RE: 150 Steeles Avenue East and 248, 250 & 314 Martin Street, Milton, Proposed Mixed-Use Development

This memorandum is intended to provide additional information to address the Town’s transportation-related comments dated April 2, 2026 and April 8, 2026, and the Region’s transportation comments dated April 17, 2026, in regard to BA Group’s February 2026 Transportation Considerations Report (“the February 2026 BA Group Report”). We trust that the enclosed memorandum provides the appropriate information requested by the Town. Please feel free to let us know if you have any questions or require any additional information.

1.0 BA GROUP RESPONSES TO TOWN COMMENTS

150 STEELES
VEHICLE MANOEUVRING DIAGRAM
MARTIN STREET / STREET A
HALTON REGION GARBAGE TRUCK

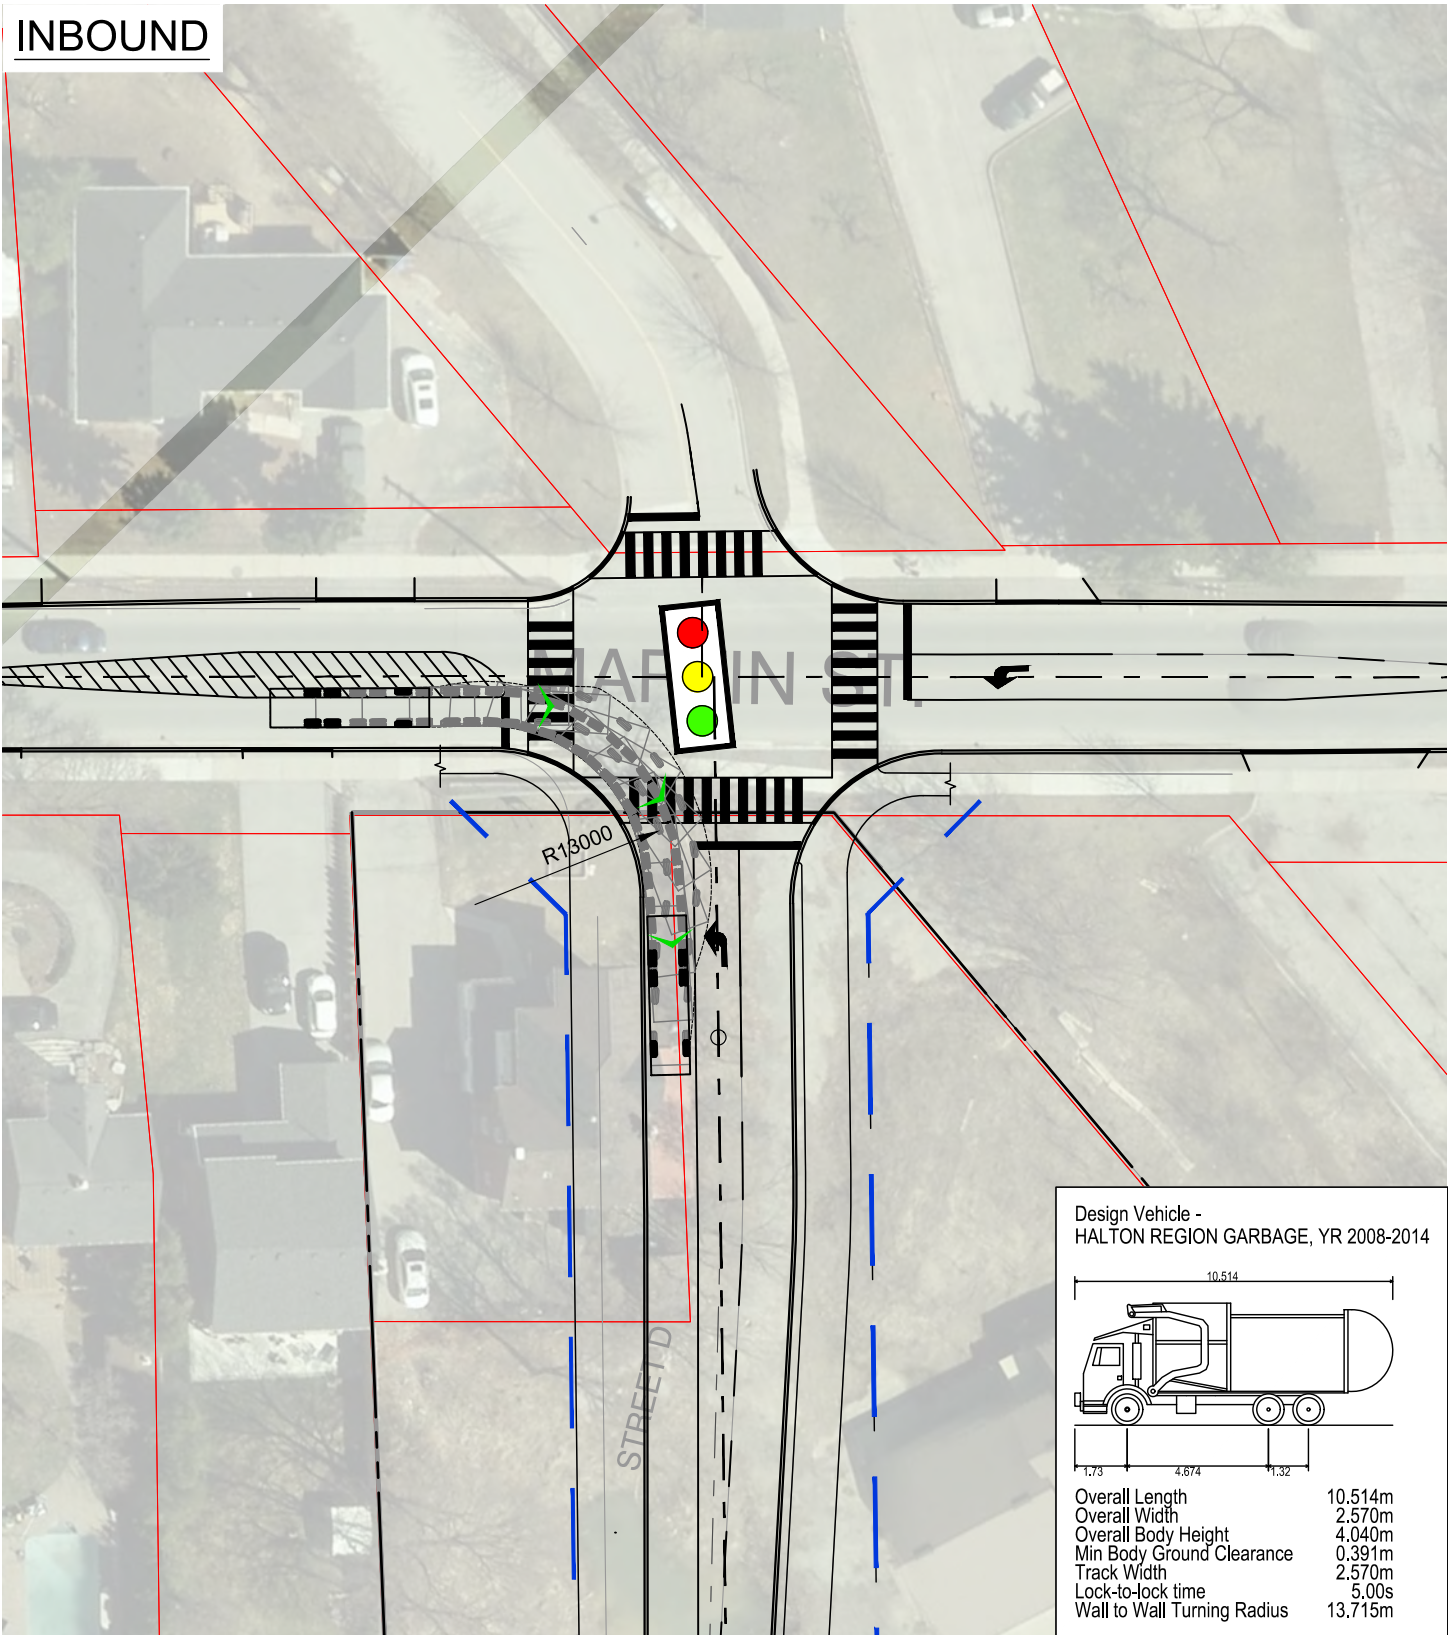
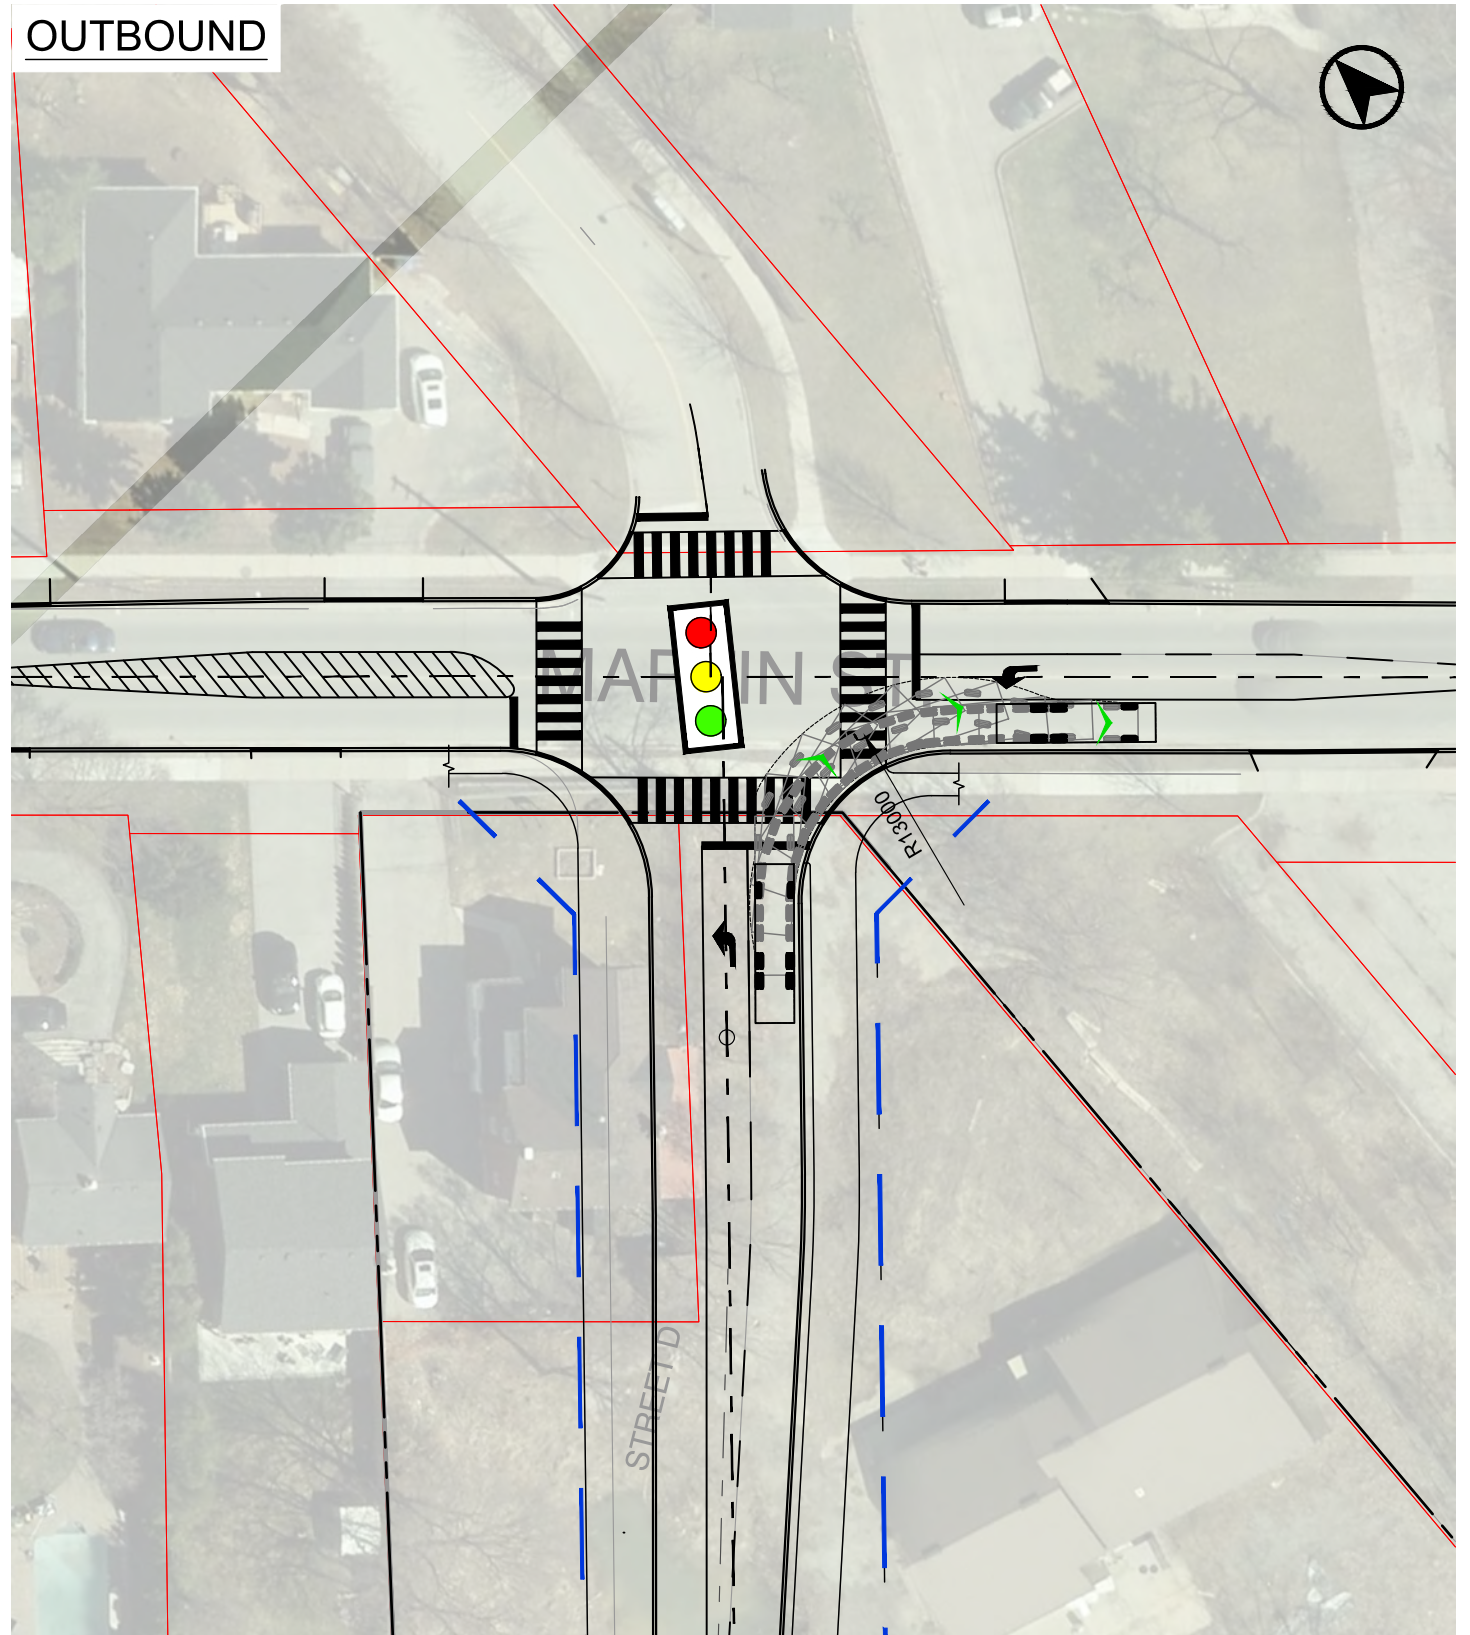
Comment: Please indicate the centreline turning radius in all locations where the waste collection vehicle is turning and approaching loading area (minimum 13 metres).

Comment: Please indicate the length of the head-on approach (minimum 18 metres).

Comment: Please indicate the distance the waste collection vehicle will be required to reverse (maximum 18 metres).

Comment: Please indicate the waste collection vehicle route from the municipal road to the Collection Point and back to the municipal road. Please ensure to include the turning radius of all turns.

Comment: Where continuous forward movement of waste truck cannot be achieved, a cul-de-sac or T-turnaround may be permitted if 13m turning radius and max 18 metre backup distances can be met.

Comment: Notwithstanding the loading requirements set out in the Town 's Zoning By-law, the loading spaces in Phase 1 of the development are proposed to be 12 m x 3.5 m (overhead waste collection) in size.

- All dimensions on the below loading areas including centre line turning radii.
- One truck maneuvering diagram. The overlay provided below makes it difficult to determine the path of the collection vehicle.

Response: The centreline turning radius of a minimum of 13 metres is illustrated on the Vehicle Manoeuvring Diagrams (VMDs) attached in **Appendix C**.

Response: The 18 metres head-on approach is illustrated on the VMDs attached in **Appendix C**.

Response: The reversal distance of the waste collection vehicle is illustrated on the VMDs attached in **Appendix C** and illustrate reversal distances of 18 metres or less.

Response: VMDs provided in **Appendix C** illustrate waste collection vehicles entering each block from the municipal road and leaving each block onto the municipal road.

Response: VMDs provided in **Appendix C** illustrate waste collection vehicles entering and existing each site in a forward motion. The turning radius (minimum 13 metres) and the reversal distances (maximum 18 metres) are illustrated on the VMDs.

Response: Vehicle Manoeuvring Diagrams provided in **Appendix C** illustrate the waste collection vehicle entering and exiting the proposed waste collection areas with dimensions (minimum 13 metres turning radius, minimum 18 metres head-on approach and maximum 18 metres reversal distance).

3 STAGING/LOADING AREA
A111

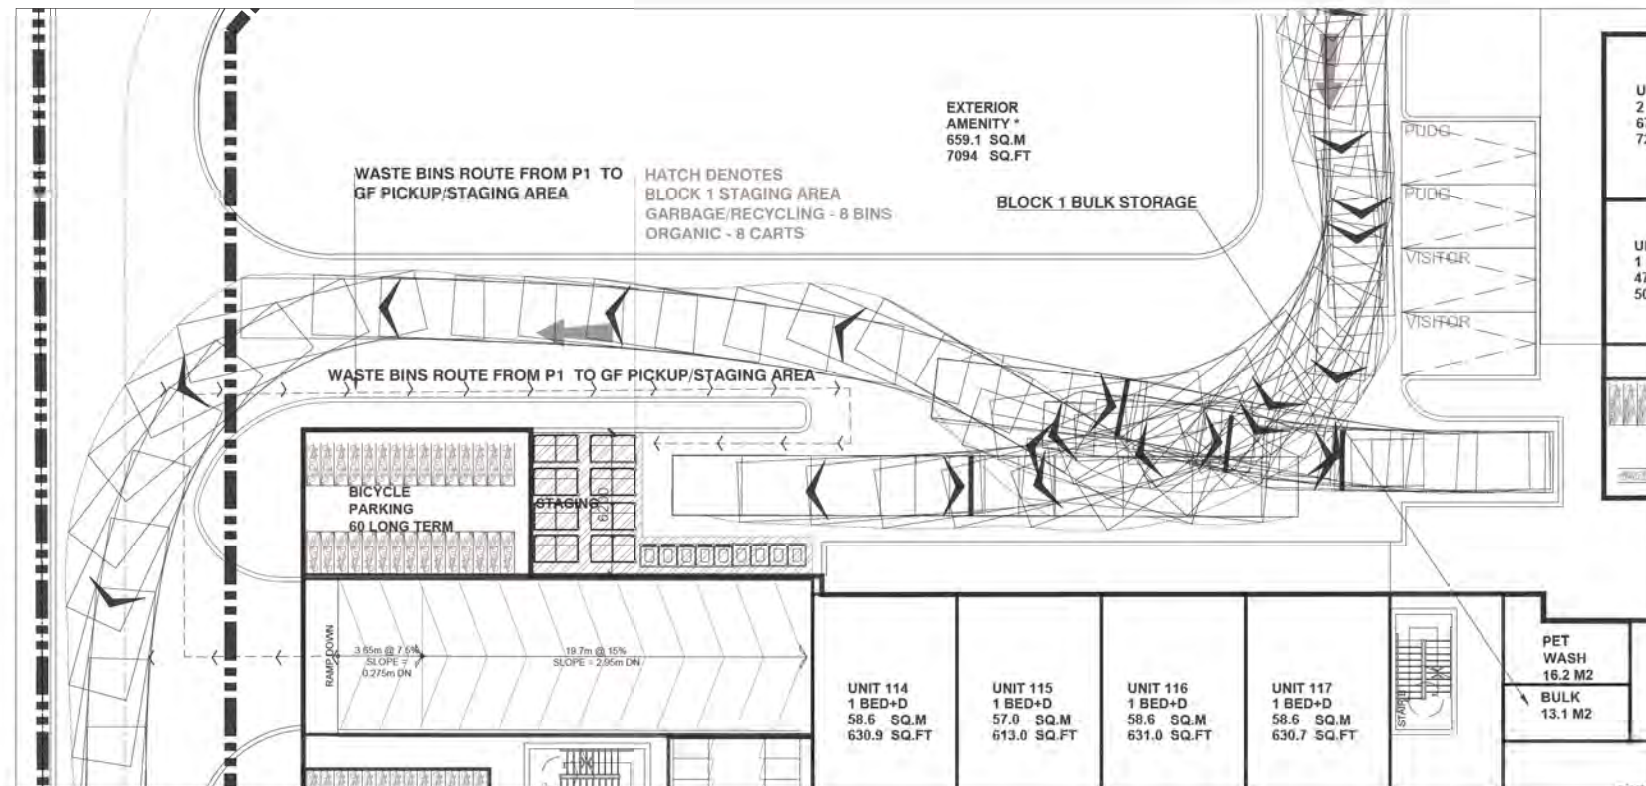
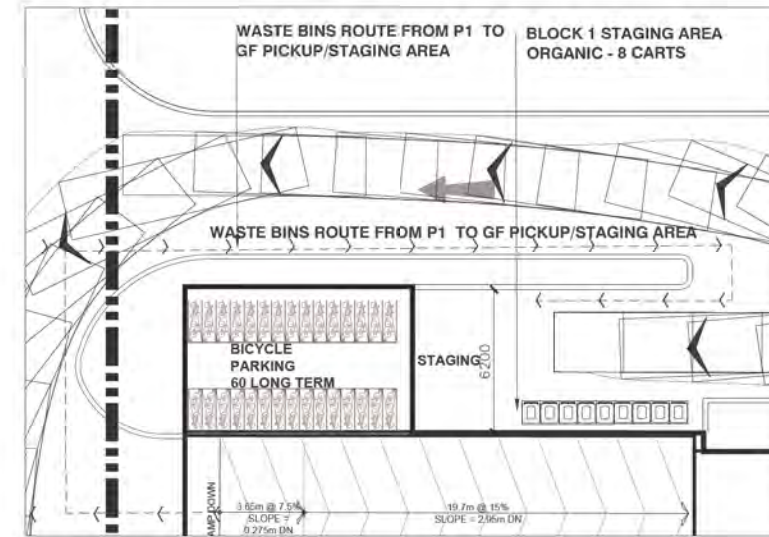
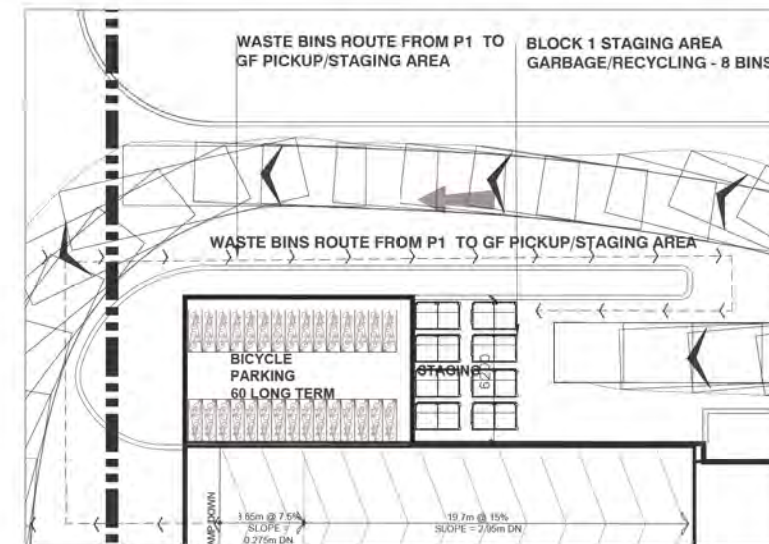
Comment: If waste collection is outside and free of overhead restrictions within the loading zone. A 5.0 minimum height clearance is required for the approach to the loading area. The minimum width of the loading area is 6.0 m.

Response: A minimum of 6.0 metres wide area for waste collection is provided and illustrated on the architectural plans attached in **Appendix D**.
